**14 CFR Part 23**

[Docket No. 27805; Amendment No. 23-48]

**Airworthiness Standards; Airframe Rules Based on European Joint Aviation Requirements**

ACTION: Final rule.

Figure A7.—Chordwise Load Distribution for Stabilizer and Elevator or Fin and Rudder

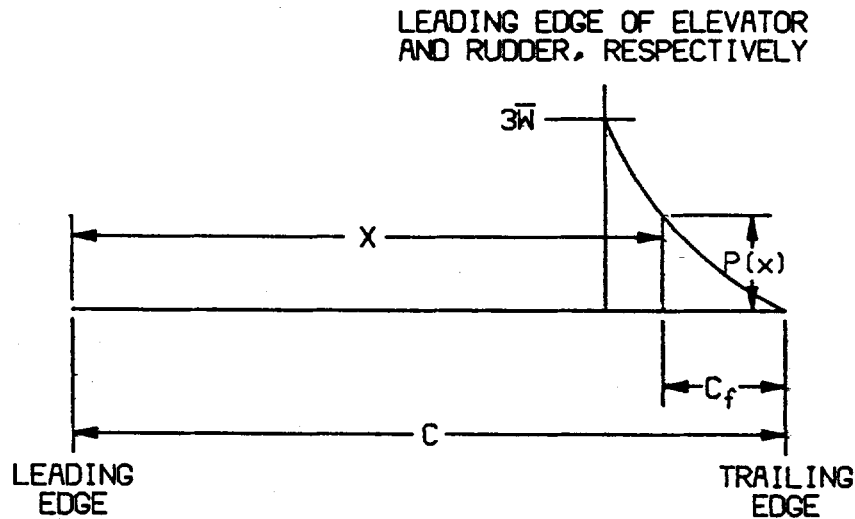
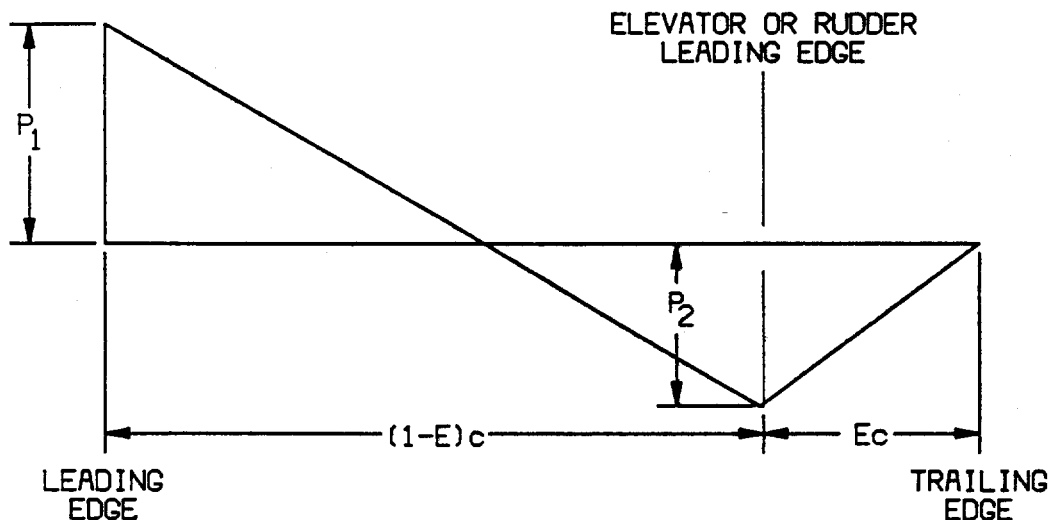
39. Appendix A is amended by revising the heading, section A23.1, paragraphs A23.11 (c)(1) and (d), and Table 2; and by adding a new Figure A7 to the end of the Appendix to read as follows:

(ii) The load on the stabilizer and elevator, and the load on fin and rudder, must be

distributed chordwise as shown in figure 7 of this appendix.
